# SERVICE BULLETIN

**SUBJECT:** PN 369H7825 DROOP CONTROL BELLCRANK ASSEMBLY (STATION 68.0) - RELOCATION OF LOCKNUT AND INSTALLATION OF SPACER\*

**MODELS AFFECTED:** 500D Model 369D Helicopter Serial No. 0003D thru 0529D

Figure 1. Relocation of Locknut - Station 68.0 Bellcrank Assembly

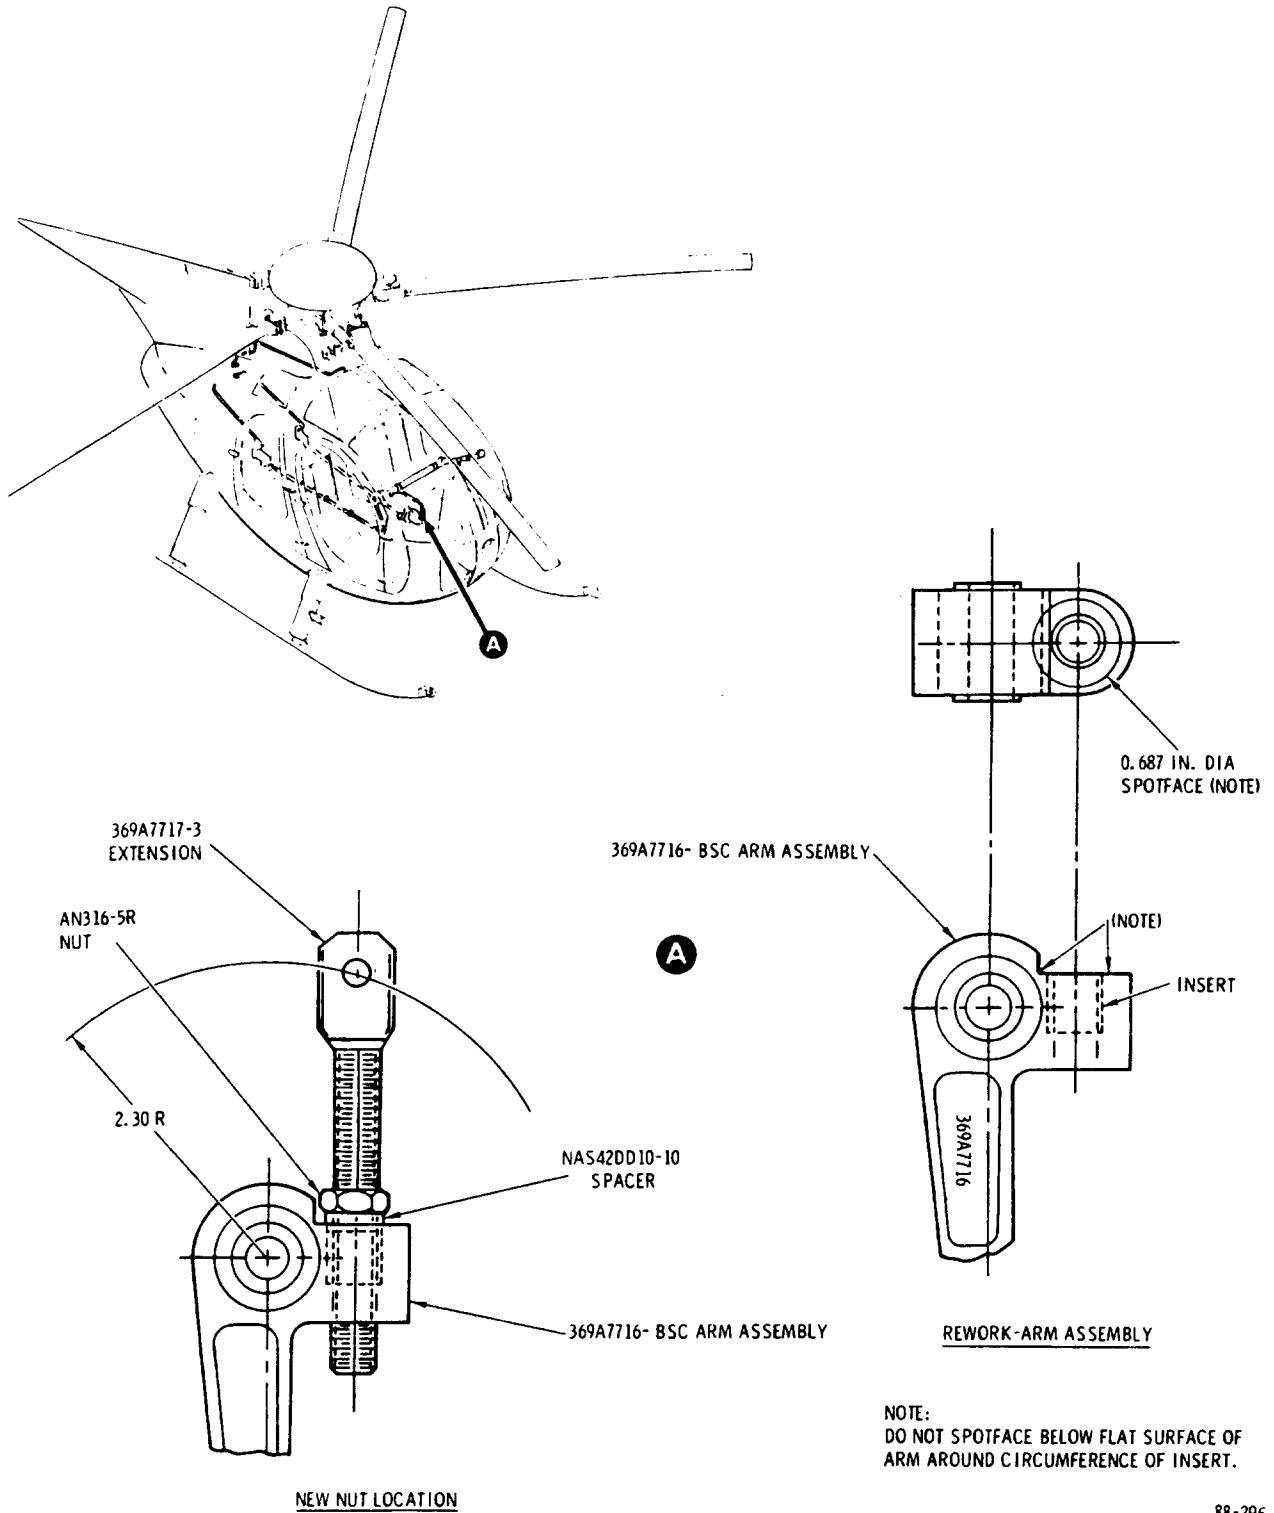
**PREFACE:** The information given in this Service Information Notice lists instructions for installing the existing droop compensation adjustment locknut on the PN 369A7717-3 extension at a new location above the PN 369A7716 (magnesium) or PN 369N2606 (aluminum) arm assembly. Relocation of the locknut precludes loosening and/or loss of the locknut during helicopter operation.

Instructions are also provided for rework of the arm assembly to provide a fiat interface with a new spacer installed between the locknut and arm assembly.

Spotface thru radius of arm only. DO NOT spotface below flat surface of arm around circumference of insert in arm.

- Spotface PN 369A7716 or 369N2606 arm assembly, as shown in figure 1.

- d. Touch up reworked surface of arm with Dow 7 or Dow 17 chemical treatment. Apply zinc chromate primer to reworked area.
- e. Install existing locknut and new NAS42DD10-10 spacer on -3 extension; reinstall extension. (See Figure 1.)
- f. Perform rigging of power turbine governor controls, per Basic HMI - Vol I.
- g. Reinstall control covers and floor access panels.
- h. Record compliance with this Service Information Notice in Compliance Record of helicopter Log Book.
